ADDENDUM NO. 01
BID NUMBER 595
PIERCE TRANSIT MAINTENANCE BASE
BUILDING 4 PARKING AND FUEL & WASH CIVIL

DATE: August 18, 2020

1. Marked-up Drawing CP-111 through CP-113 (For tax application demarcation reference only)
2. Huitt-Zollars Addendum #1 Drawings dated 08/17/2020
3. Huitt-Zollars Addendum #1 Design Revisions Narrative dated 08/14/2020

**ADDENDUM 01
TAX APPLICATION DEMARCATATION**

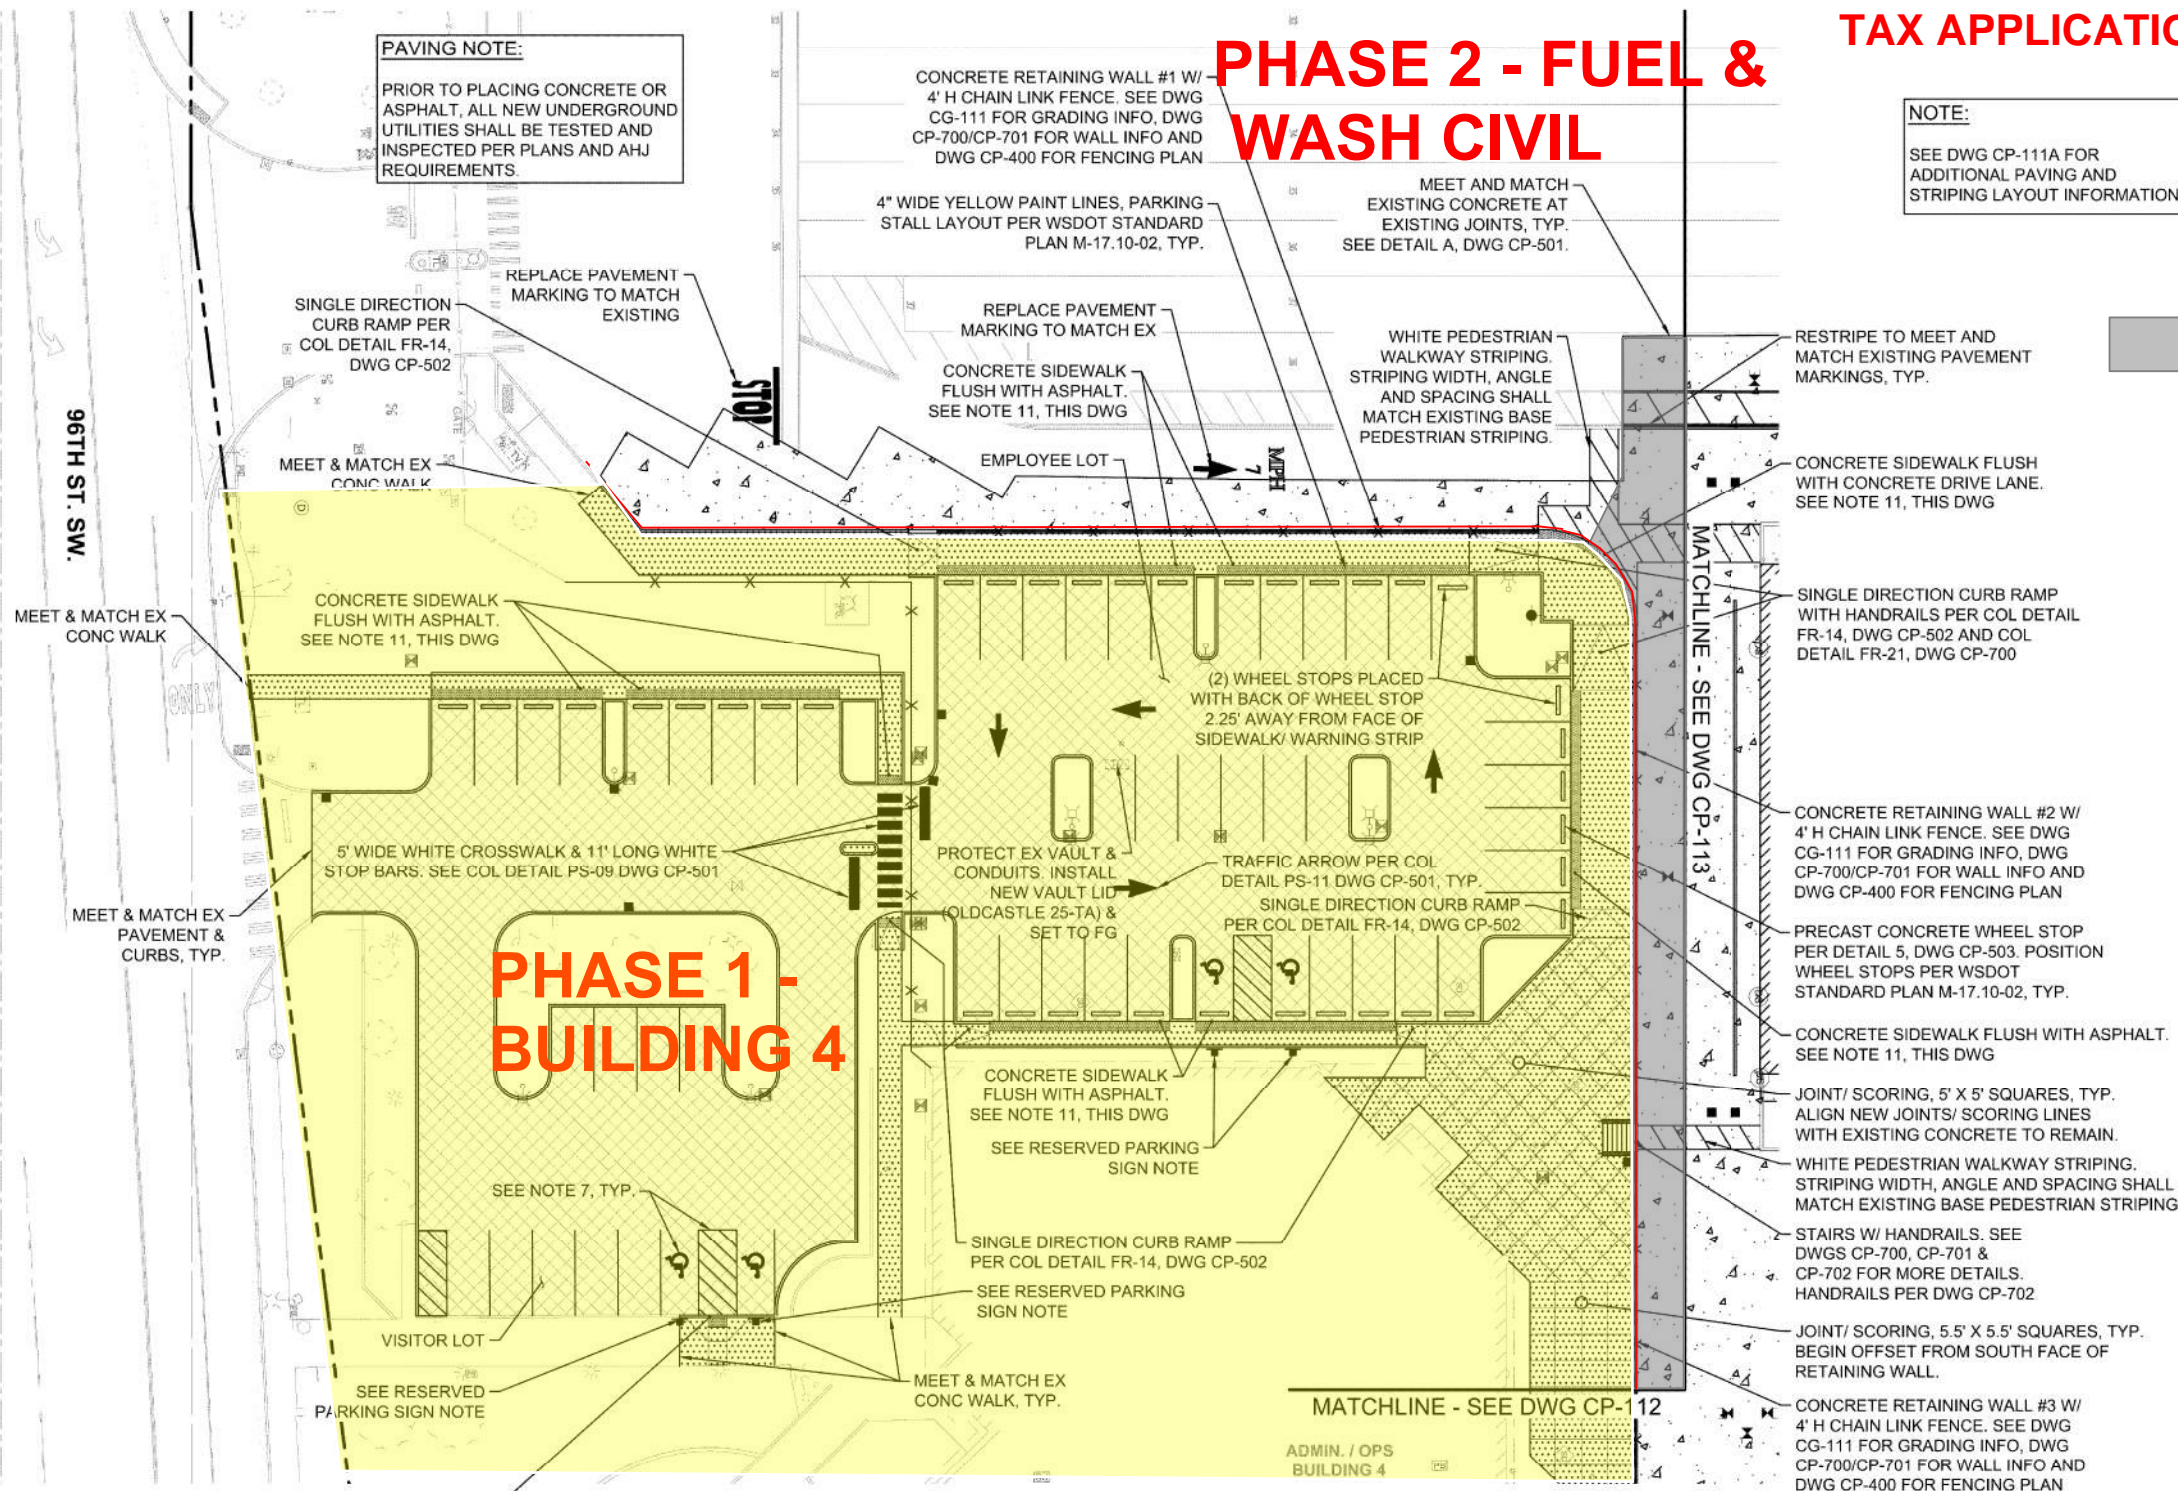
Item	Reference	Direction
1		Marked-up Drawing CP-111 to CP-113 is provided for reference to denote demarcation of Phase 1 (Building 4 Parking) and Phase 2 (Fuel & Wash Civil) for tax identification purpose only. Note: Fence, curb, retaining wall and footings along the boundary are to be included in Phase 1. Phase 2 is exempt from Washington State Sales Tax but is subject to Use Tax. Bidders are to include Use Tax for Phase 2 scope only. WSST is to be excluded from the bid amount for both phases. Note: Construction phasing for schedule remains the same per the Supplemental Document Exhibit 6 – Site Logistics Plan.
2		CHANGE Proposal Due Date: Submit bid proposals on August 26, 2020 by 2:00 pm PDT.
3		CHANGE Bid Opening Date: August 26, 2020 at 3:30 pm PDT
4	GI-001	Replace the sheet with Huitt-Zollars Addendum #1 Drawing
5	CD-113	Replace the sheet with Huitt-Zollars Addendum #1 Drawing
6	CD-114	Replace the sheet with Huitt-Zollars Addendum #1 Drawing

DRAWING No.: **CP-501**
SHEET No.: 24 OF 70

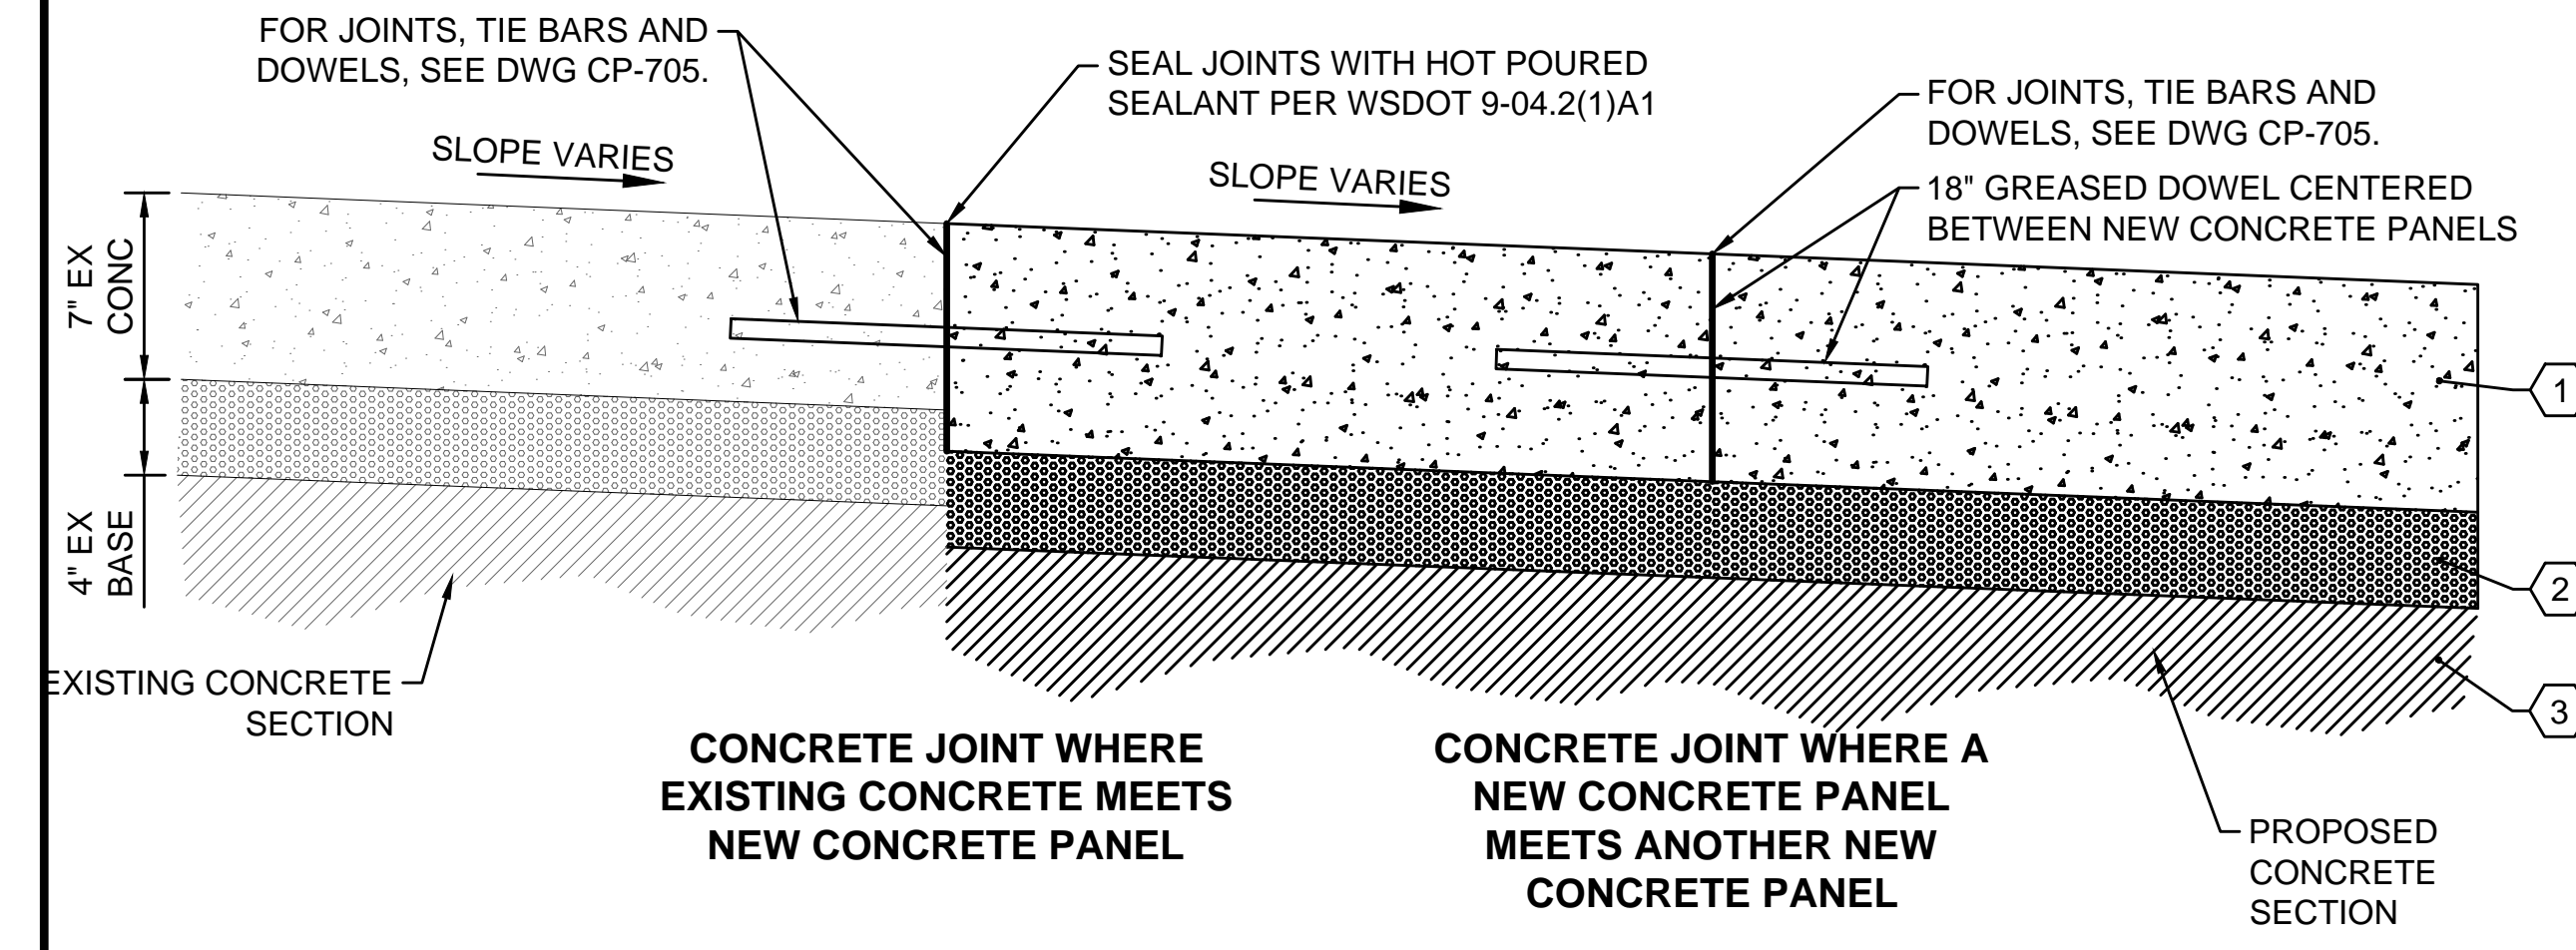
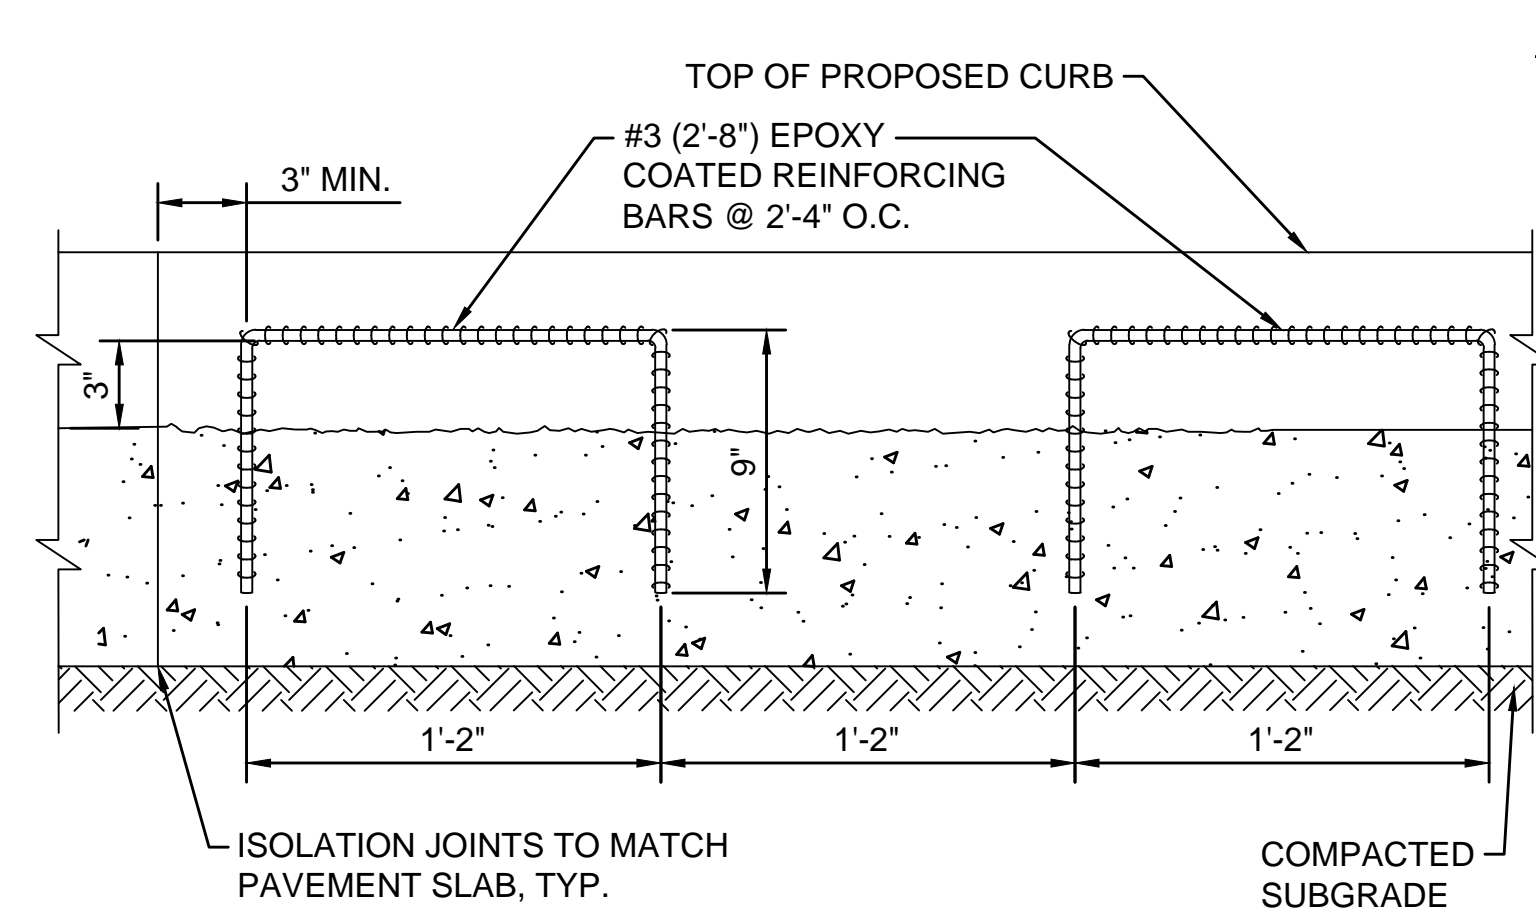
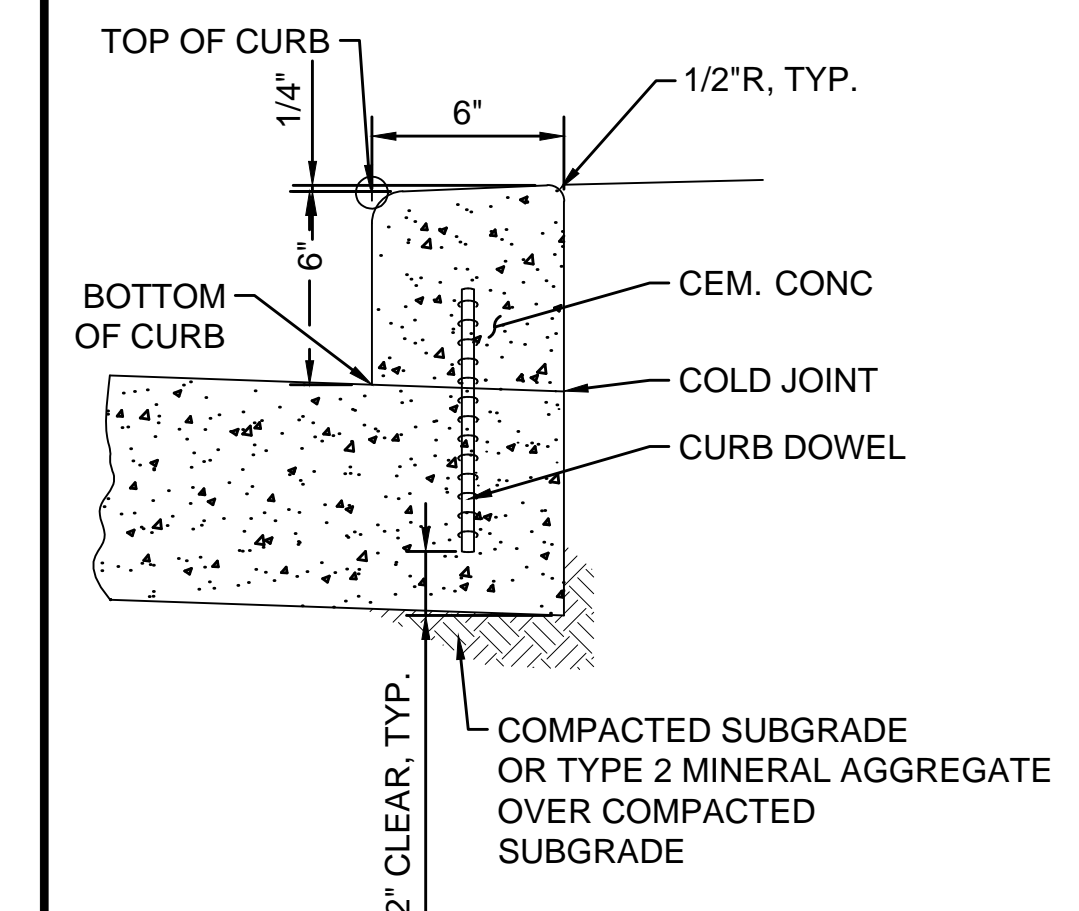
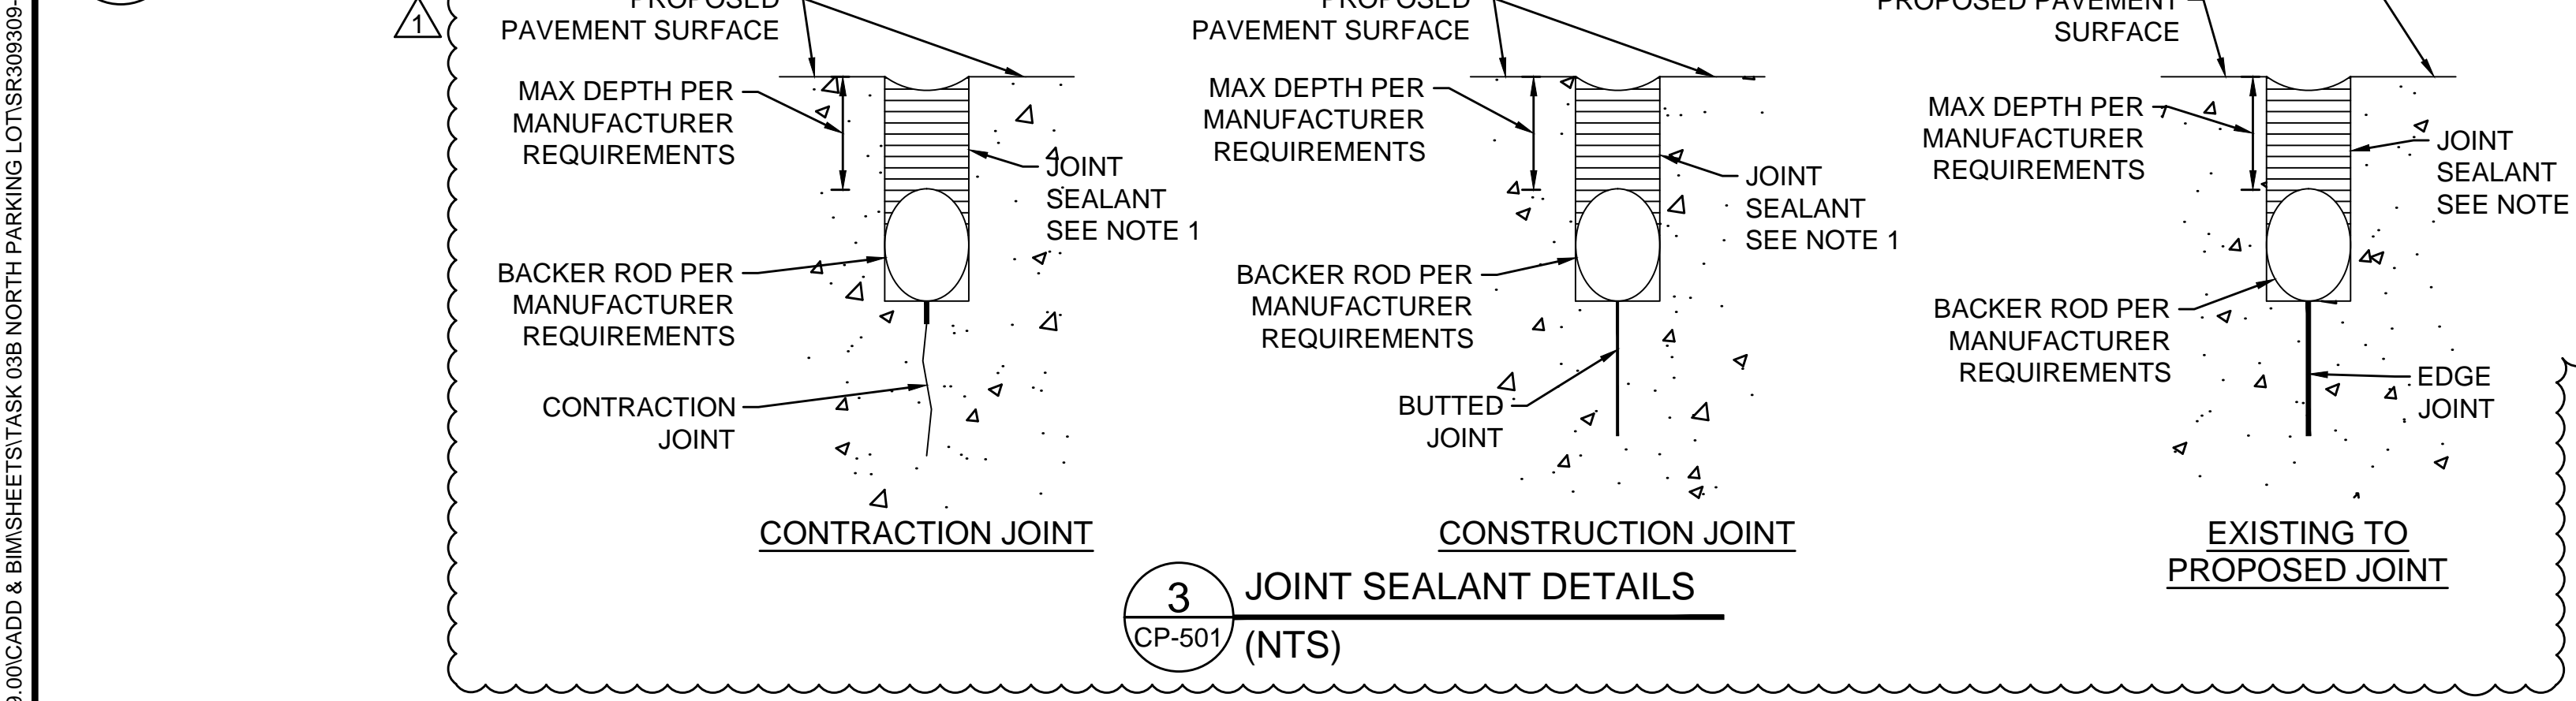
#	DWG/Spec	Description	Comment
5	CP-501	Revise Light Duty Pavement Section B.	
6	CP-501	Add joint sealant details.	
7	CP-503	Add Detail 9 and add surface mount base plate note to Detail PS-05.	
8	CP-503	Revise bollards to be schedule 40 steel.	
9	CP-504	Add "TYPICAL FENCE NOTES".	
10	CP-504	Detail A – CNG TRENCH DETAIL is Not In Contract (NIC)	
11	CP-510	Clarify gate equipment and appurtenances.	
12	CP-700	Revise ramp handrails to be galvanized.	
13	CP-701	Add reinforcement at bottom of stairs.	
14	CP-701	Revise width of wall footing.	
15	CP-703	Revise light pole base details and note number of conduits in pole bases.	
16	CP-705	Revise entire sheet.	Revise concrete paving reinforcement details.
17	CP-706	Revise concrete strength for vertically formed walls.	
Electrical			
1	UE-111 & UE-113	Add note #7, re-number notes #8 and #9.	
2	UE-111	Add callout for Building 4 communications connection point.	
3	UE-111	Add gate reference callout.
